LiDAR Quality Assessment Report

MO_Adair_2012

Adair Co is part of the Missouri Grand 2011 LiDAR dataset. The St. Louis District of the United States Army Corps of Engineers (USACE) contracted with Surdex Corporation in the fall of 2011 to collect high resolution LiDAR elevation data over multiple counties as part of the Missouri Grand Counties Lidar Project. This project consists of 4 delivery blocks including all or part of Howard, Cooper, Montgomery, Livingston, Randolph, Monroe, Audrain, Lincoln, Macon, Adair, Sullivan, Putnam, and St. Louis City and County. There is additional coverage within Ray, Gasconade, St. Francois and Jackson Counties. The project combines the varied interests of the NRCS, USGS, USACE and State Emergency Management Agency (SEMA) totaling over 6287 square miles into a unified collection and processing project to benefit the US Government. The NRCS shall serve as the technical point of contact with the USACE St Louis District. This QA report covers Adair Co and is part of delivery block 2

Project QA/QC Report Review

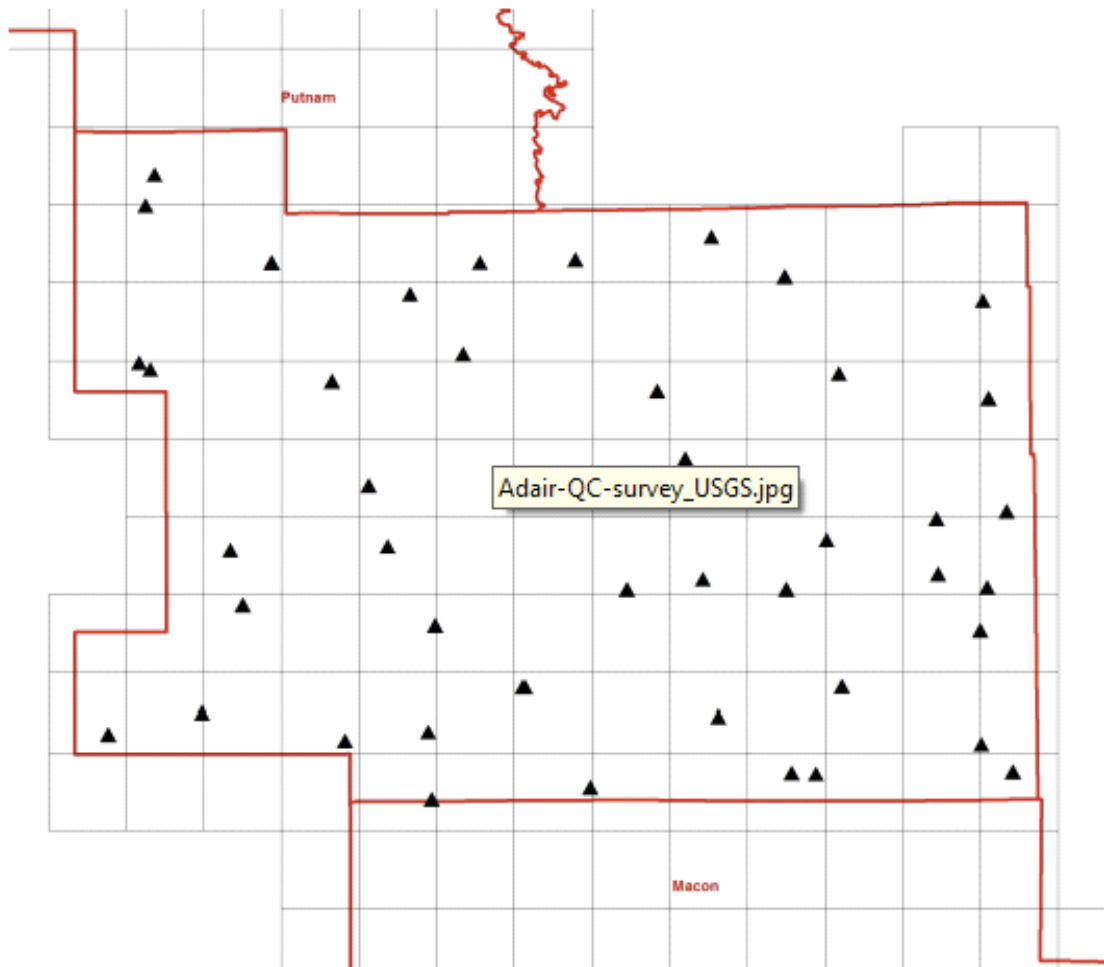
There are a minimum of 20 checkpoints for each land cover class represented. Points within each class are uniformly distributed throughout the dataset. USGS was notable to locate independent checkpoints for this analysis. USGS accepts the quality of the checkpoint data for these LiDAR datasets.

NGTOC vertical accuracy test results are exactly the same as the reported results. It is suspect that the points are not truly blind points.

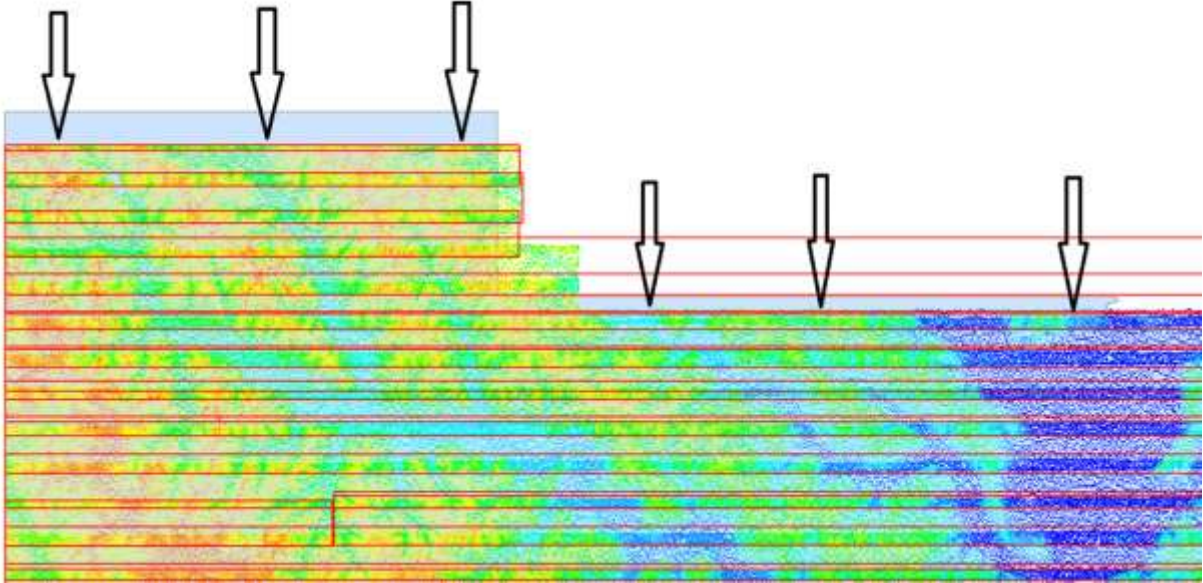
Scan angle seems excessively wide.

Min Scan Angle (SAMN) = -48.

Max Scan Angle (SAMX) = 44.

In the Project Overview section, pg. 2 of 5, of the "LiDAR Acquisition Processing Summary" the table shown above specifies parameters used in preparing the flight plan for Adair Co. Field of View (FOV) of 34 degrees. The Min (SAMN) and Max (SAMX) Scan Angle should not exceed + or - 17 degrees from Nadir. Scan Angles extremely exceed these parameters. The scan angles reported in LP360, -48 and 44, exceed Leica ALS- 50 II system accuracy limits of 75 degrees (FOV) + or - 37.5 degrees from Nadir.

Accuracy testing supports the data and it is the opinion of NGTOC that the data is correct and the scan angles have been recorded in error. Please explain why scan angle exceeds FOV in the project flight plan and the Leica ALS-50 II capabilities.

Note Flying altitude is always referred to as Above Ground Level (AGL) not Above Mean Sea Level (AMSL)

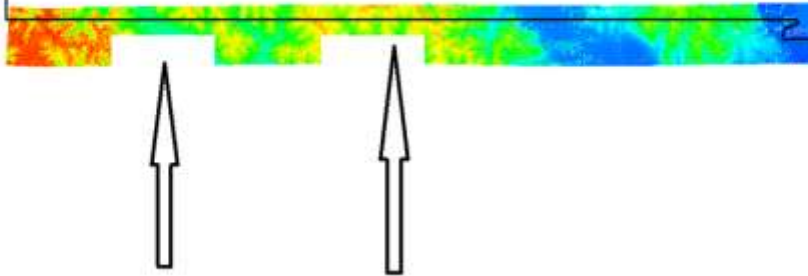
Missing swath on north edge of Adair Co MO. Missing swath data in blue area of footprint. Swath data (LDR111115_220043_1.las, LDR111115_212601_1.las) for the north edge of Adair Co MO are included in Putnam Co MO, however, point data on the north edge are still missing in LDR111115_212601_1.las. See image below

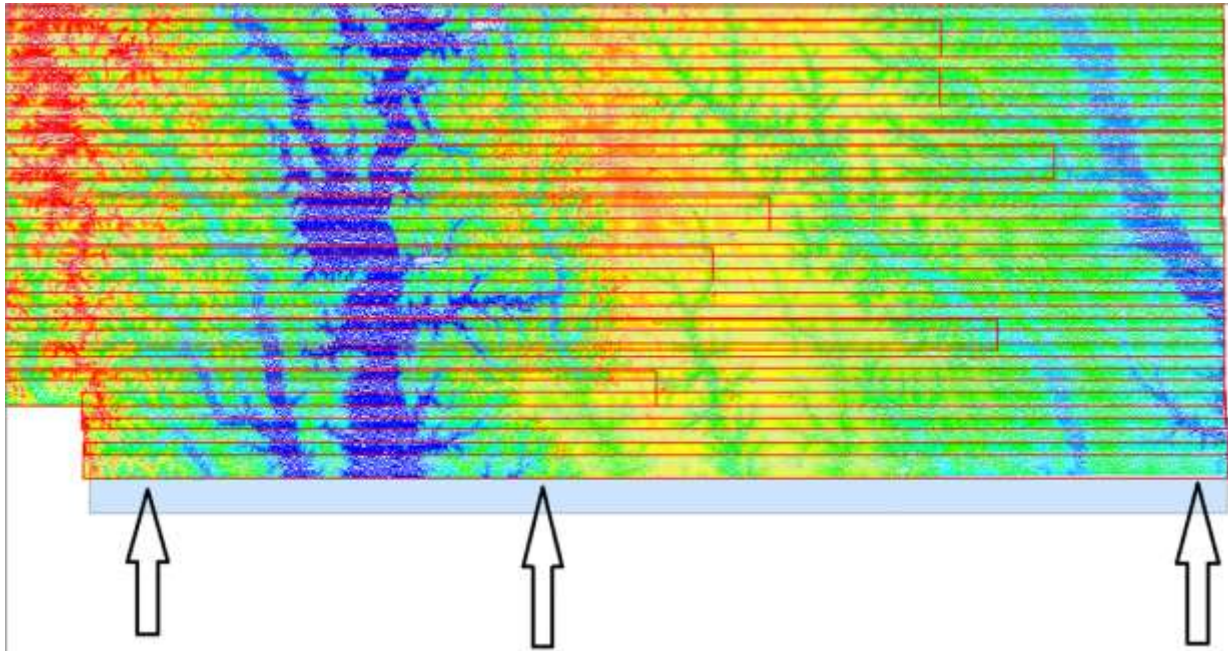
Point data in swath missing in LDR111115_212601_1.las on north edge of Adair Co MO.

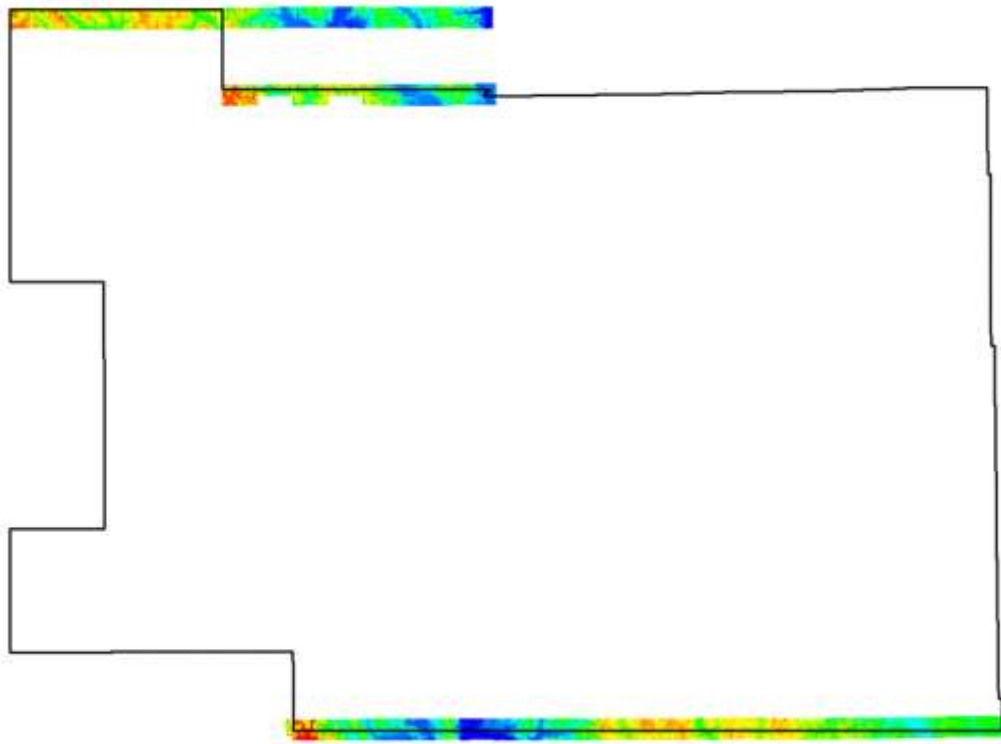
Missing swath on south edge of Adair Co MO. Missing swath data in blue area of footprint. Swath data (LDR111129_195512_1.las) for the south edge of Adair Co MO are included in Macon Co MO.

Available swath data in Macon and Putnam Cos. MO to cover north and south edge of Adair Co MO.
